**Flood Control Project Maintenance
Levee Inspections**

Fall 2019 Levee Maintenance Deficiency Summary Report

**Flood Control Project Maintenance
Levee Inspections****LMA District Cover Sheet****Fall 2019 Levee Inspection Results****Reclamation District No. 0003 Grand Island**

Reclamation District No. 0003 Grand Island

Photo 3 of 4 : FA_2019_RD0003_24_188_20190826_00092.jpg

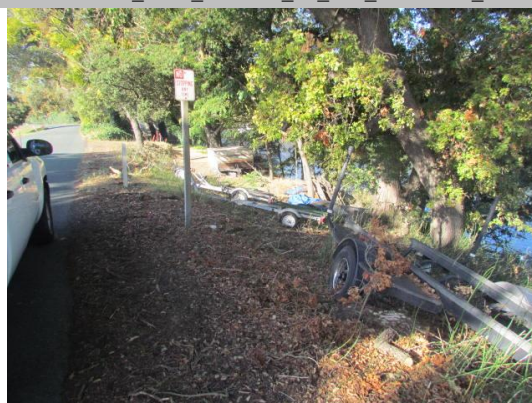
LM Start	0.21	Rating **	M	Issue No.	188
LM End	0.21	Issue Type +	En	Location *	WS
Category	Earthen Levee			GPS Latitude/Longitude	
				Start	End
Item	Encroachments			38.302625 °	38.302625 °
				-121.577683 °	-121.577683 °
DWR ID	DWR_RD0003_01_s_2012_188				
Comment Code					
GA : Garbage					
Inspector Comment					
Landowner has piled wooden boards and trash on waterside berm.

Photo 2 of 2 : FA_2019_RD0003_24_62_20190826_00050.jpg

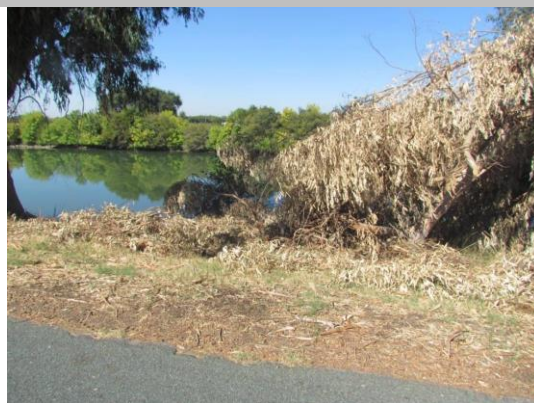
LM Start	1.69	Rating **	M	Issue No.	62
LM End	1.69	Issue Type +	Ma	Location *	WS
Category	Earthen Levee			GPS Latitude/Longitude	
				Start	End
Item	Encroachments			38.283747 °	38.283747 °
				-121.587622 °	-121.587622 °
DWR ID	DWR_RD0003_01_f_2016_62				
Comment Code					
TR : Tree or limb					
Inspector Comment					
There is a broken tree branch on the waterward slope.

Photo 1 of 1 : FA_2019_RD0003_24_20_20191031_00177.jpg

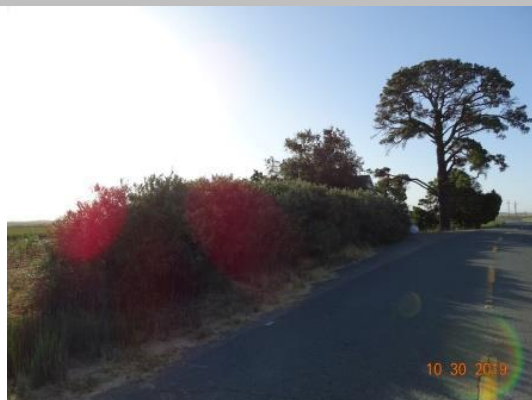
LM Start	3.11	Rating **	U	Issue No.	20
LM End	3.13	Issue Type +	En	Location *	LS
Category	Earthen Levee			GPS Latitude/Longitude	
				Start	End
Item	Vegetation			38.264902 °	38.264580 °
				-121.587193 °	-121.587220 °
DWR ID	DWR_RD0003_01_s_2012_20				
Comment Code					
V6 : Landscaping					
Inspector Comment

Photo 2 of 3 : UCIP_FA_2019_31083_56981.jpg

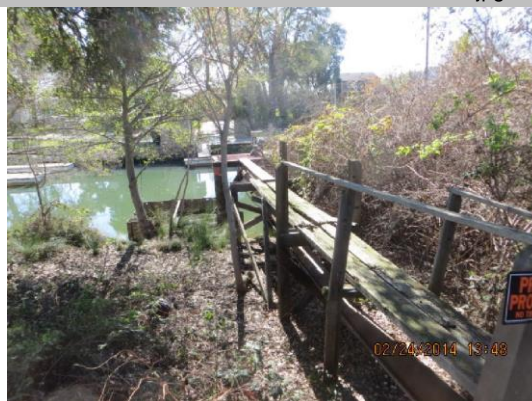
Pump on pier on WS slope. Wooden walkway failing.

Photo 1 of 1 : FA_2019_RD0003_25_48_20190826_00034.jpg

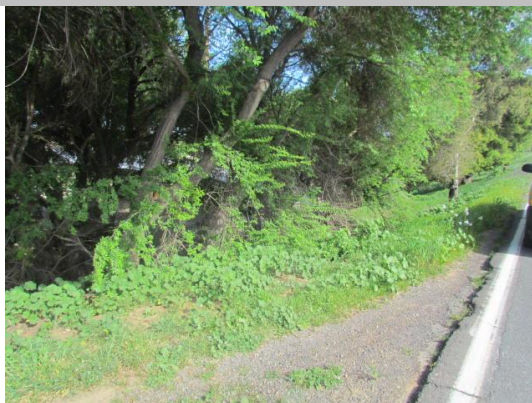
LM Start	4.14	Rating **	A/W	Issue No.	48
LM End	4.14	Issue Type +	En	Location *	LS
Category	Earthen Levee			GPS Latitude/Longitude	
				Start	End
Item	Vegetation			38.179160 °	38.179160 °
				-121.590247 °	-121.590247 °
DWR ID	DWR_RD0003_02_f_2018_48				
Comment Code					
V6 : Landscaping					
Inspector Comment

Photo 1 of 1 : FA_2019_RD0003_25_78_20190826_00057.jpg

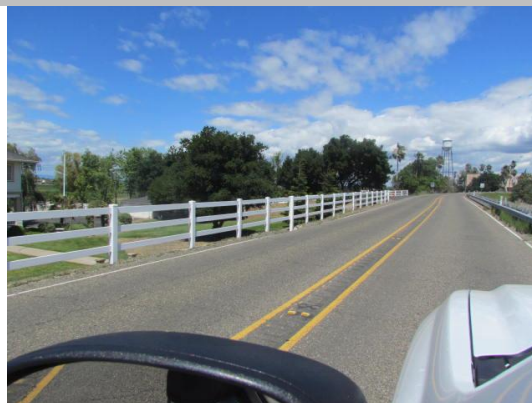
LM Start	8.85	Rating **	M	Issue No.	78
LM End	8.93	Issue Type +	En	Location *	LS
Category	Earthen Levee			GPS Latitude/Longitude	
				Start	End
Item	Encroachments			38.234516 °	38.235630 °
				-121.559502 °	-121.559640 °
DWR ID	DWR_RD0003_02_s_2013_78				
Comment Code					
FE : Fence					
Inspector Comment					
There is an unauthorized fence along this stretch.

Photo 1 of 1 : FA_2019_RD0003_25_64_20190826_00043.jpg

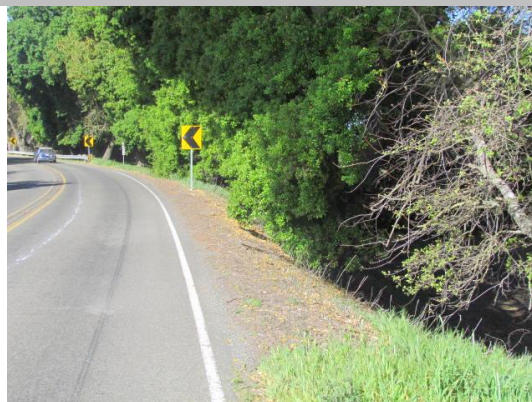
LM Start	9.56	Rating **	M	Issue No.	64
LM End	9.62	Issue Type +	Ma	Location *	LS
Category	Earthen Levee			GPS Latitude/Longitude	
				Start	End
Item	Trim / Thin Trees			38.242392 °	38.242501 °
				-121.552862 °	-121.551632 °
DWR ID	DWR_RD0003_02_s_2012_64				
Comment Code					
T1 : Trim trees to at least five feet above ground level.					
Inspector Comment

Photo 1 of 1 : FA_2019_RD0003_25_148_20190826_00127.jpg

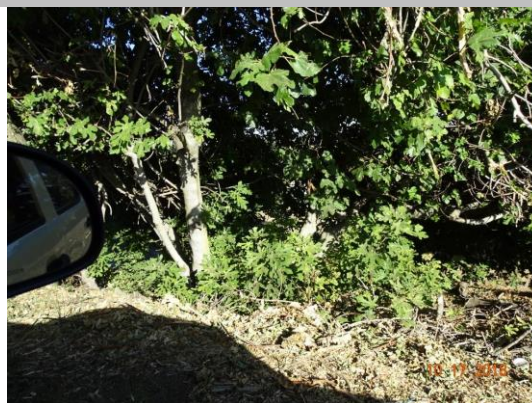
LM Start	11.21	Rating **	U	Issue No.	148
LM End	11.21	Issue Type +	Ma	Location *	LS
Category	Earthen Levee			GPS Latitude/Longitude	
				Start	End
Item	Trim / Thin Trees			38.239968 °	38.239968 °
				-121.523293 °	-121.523293 °
DWR ID	DWR_RD0003_02_f_2018_148				
Comment Code					
T1 : Trim trees to at least five feet above ground level.					
Inspector Comment					
Trim fig trees that are sprouting.

Photo 1 of 3 : UCIP_FA_2019_30353_55827.jpg

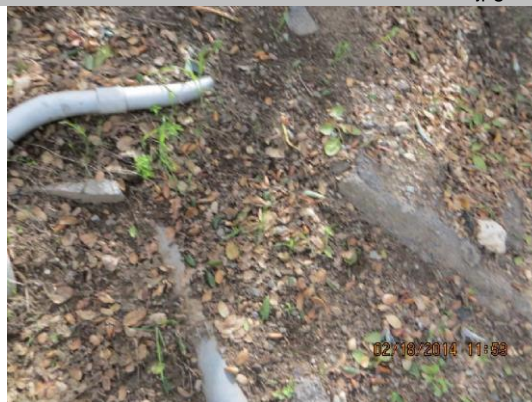
LM Start	11.63	Rating **	M	Issue No.	986
LM End	11.63	Issue Type +	En	Location *	
Category	Supplemental			GPS Latitude/Longitude	
				Start	End
Item	DRAFT DWR UCIP Field Study			38.241872 °	38.241872 °
				-121.516433 °	-121.516433 °
DWR ID	22356				
Comment Code					
Inspector Comment					
DS_ID:22356 FS_ID:30353 EP_NO: 16053 Repair Type: Non-Urgent Crossing Status: Found UCIP Comments: Annular space not grouted. FIELD_STRUCT_DESC: 2 of 4: 6-inch galvanized iron electrical conduit through the levee, 3 feet below the crown. 4-inch steel electrical conduit sleeved through the 6-inch conduit. Electrical panel visible on the landside (LS) toe. (Plans to install four 6-inch pipe casings through the levee authorized under Permit No. 16053, 1993 - Vollman-Clark Ranch, DCC Engineering Company, Inc). FS Date: 2/18/2014

Photo 2 of 2 : FA_2019_RD0003_25_72_20190826_00048.jpg

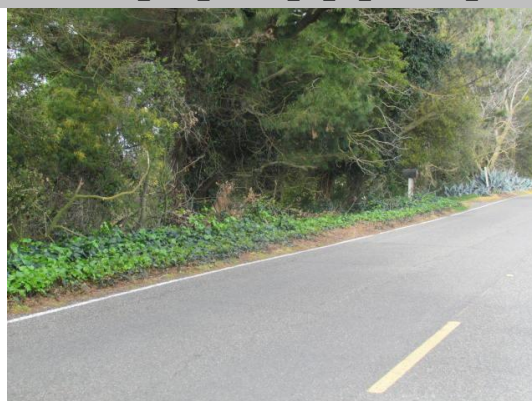
LM Start	14.68	Rating **	U	Issue No.	72 (cont)
LM End	14.84	Issue Type +	En	Location *	LS

Photo 1 of 1 : FA_2019_RD0003_25_79_20191030_00315.jpg

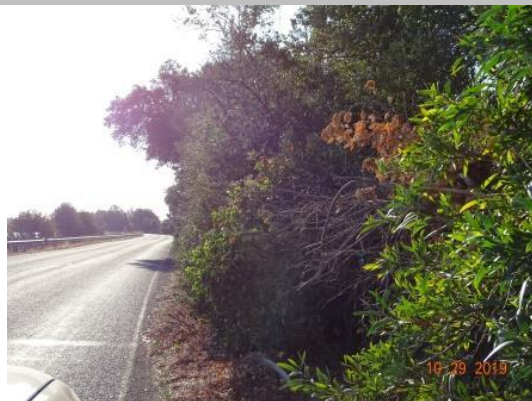
LM Start	15.58	Rating **	U	Issue No.	79
LM End	15.68	Issue Type +	En	Location *	LS
Category	Earthen Levee			GPS Latitude/Longitude	
				Start	End
Item	Vegetation			38.284124 °	38.285129 °
				-121.554084 °	-121.555342 °
DWR ID	DWR_RD0003_02_s_2012_79				
Comment Code					
V6 : Landscaping					
Inspector Comment
